Revisions:	Date
1 AMENDMENT 1	29 APR 2016

Drawing Title	Project Title	A/E Project Number	
ELECTRICAL SITE PLAN	PARKING STRUCTURE LOT 7	14-692	OFFICE OF FACILITIES MANAGEMENT
		Building Number #152	
Approved for Design Concept: FACILITY MANAGEMENT DIVISION MANAGER	Location CLEMENT J ZABLOCKI VAMC	Drawing Number EE102	VA Project Number 695-325
	Date 1 DEC 2015 / Checked By: JKM / Drawn By: SCB		VA U.S. Department of Veterans Affairs

Drawing Title: ELECTRICAL ENLARGEMENTS	Project Title: PARKING STRUCTURE - LOT 7	A/E Project Number: 14-692	OFFICE OF FACILITIES MANAGEMENT
		Building Number: #152	
Approved for Design Concept: FACILITY MANAGEMENT DIVISION MANAGER	Location: CLEMENT J ZABLOCKI VAMC	Drawing Number: EE402	VA Project Number: 695-325
	Date: 1 DEC 2015 / Checked By: JKM / Drawn By: SCB		VA U.S. Department of Veterans Affairs

1 EE102 ELECTRICAL SITE PLAN
1" = 20'

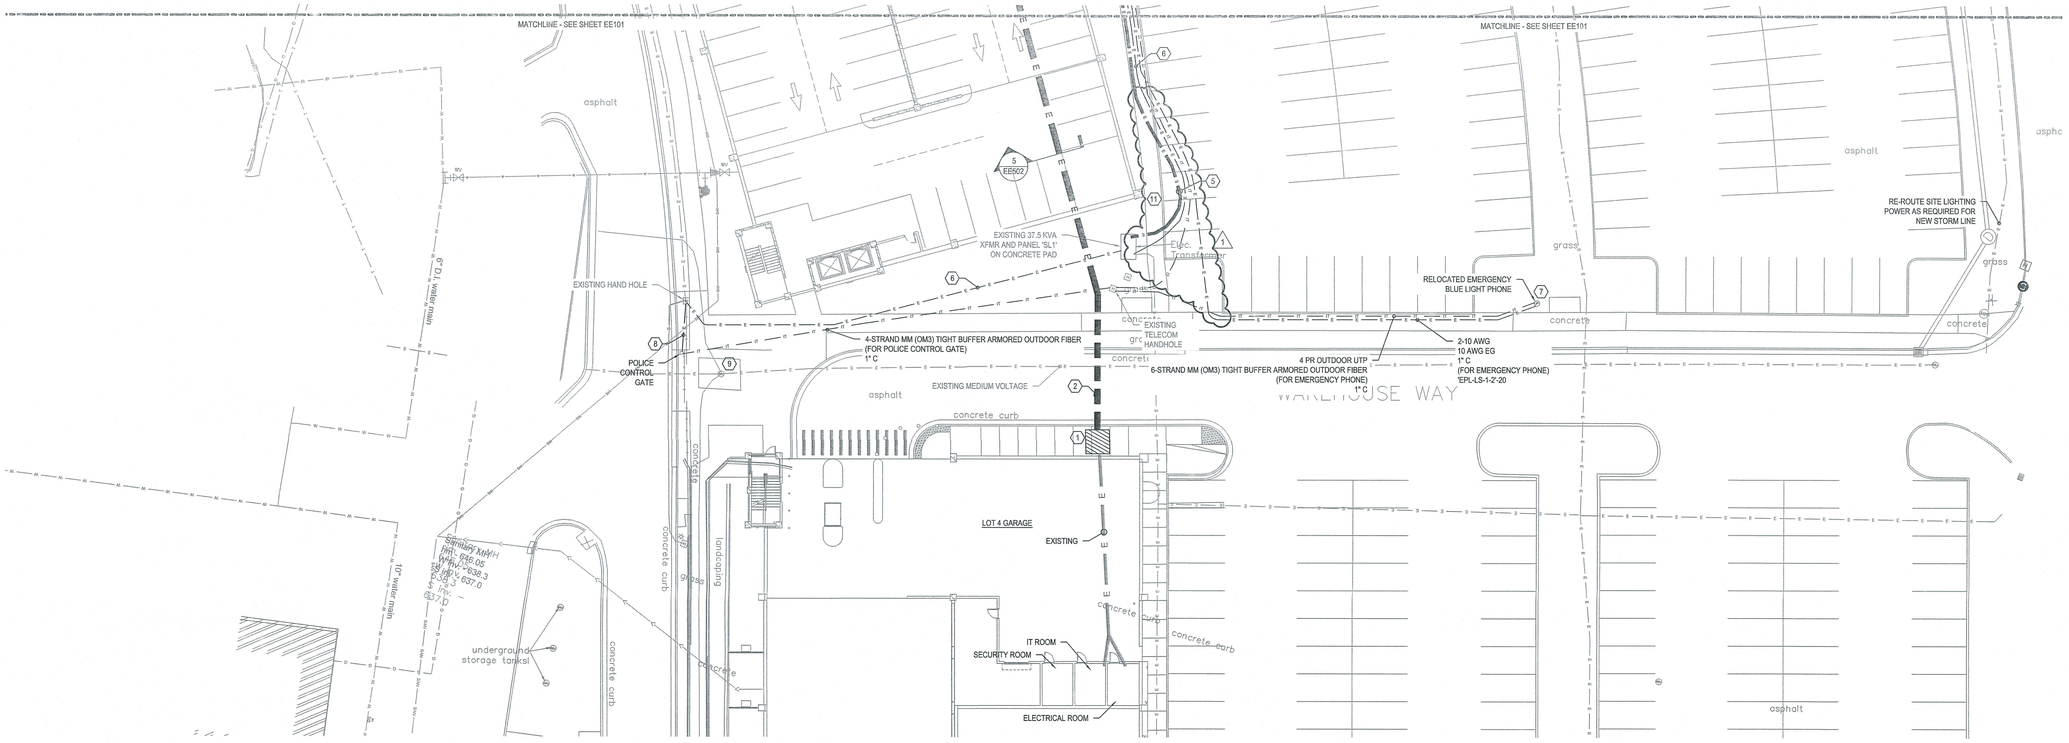
10. PROVIDE CONDUIT AND WIRING TO INTERCONNECT SIGN AND CONTROLLER PER MANUFACTURER'S INSTRUCTIONS. 1
11. COORDINATE ROUTING TO AVOID EARTH RETENTION SYSTEMS.

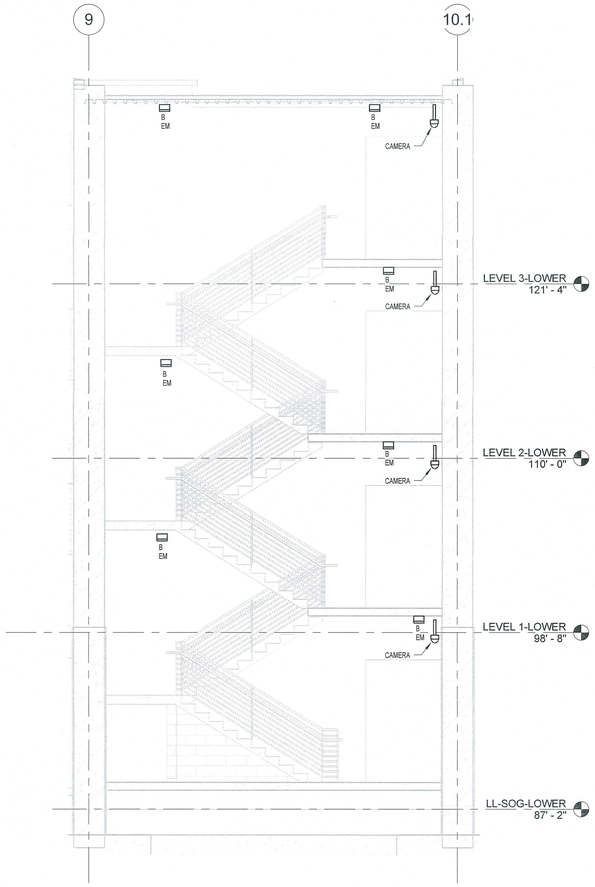
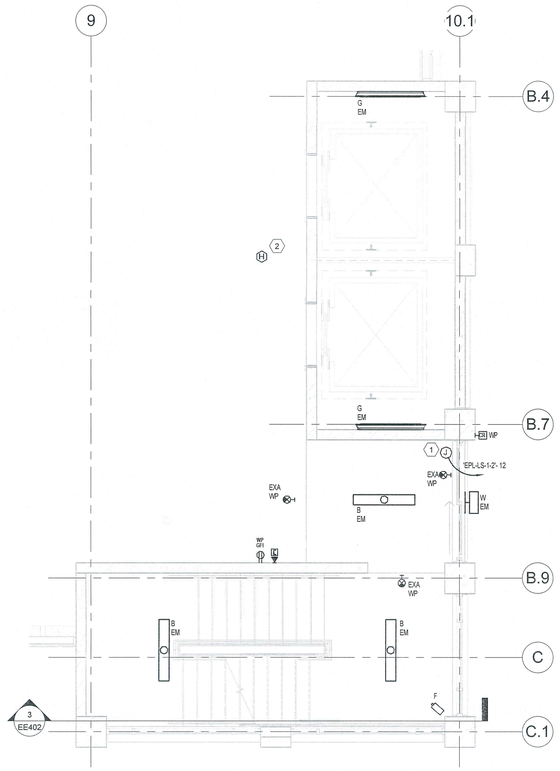
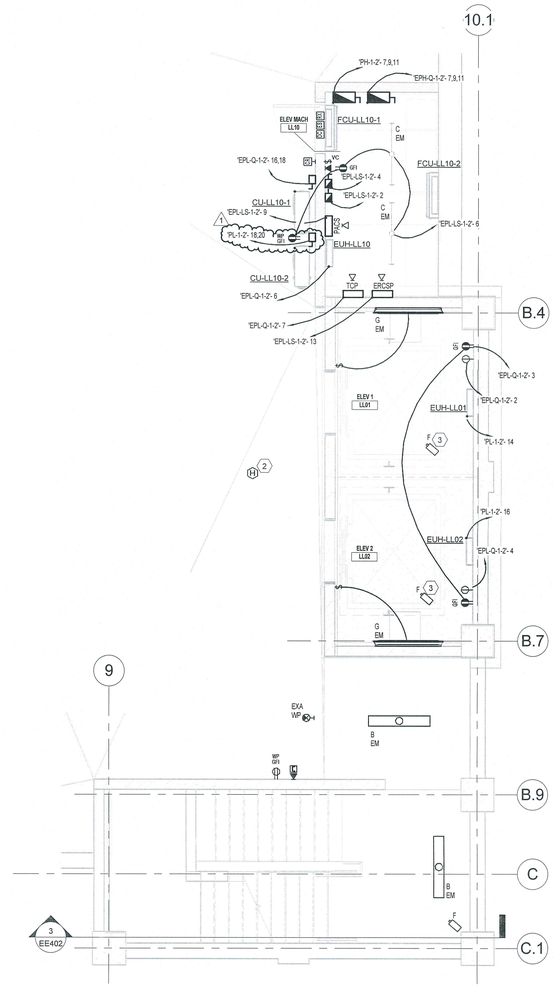
2 PROVIDE COLD-WEATHER HEAT DETECTOR WITHIN 21' OF THE CENTERLINE OF EACH ELEVATOR DOOR. SEE ELEVATOR RECALL DETAIL, EE502. COORDINATE WITH ELEVATOR INSTALLER.

3 PROVIDE CAMERA IN EACH ELEVATOR CAB. ROUTE 4PR THROUGH ELEVATOR CONTROLLER AND TRAVELING CABLE. TRAVELING CABLE CONDUCTORS SHALL BE PROVIDED BY ELEVATOR PROVIDER OR SHALL BE SHIELDED, INDUSTRIAL FOR CONTINUOUS FLEX. COORDINATE WITH ELEVATOR INSTALLER.
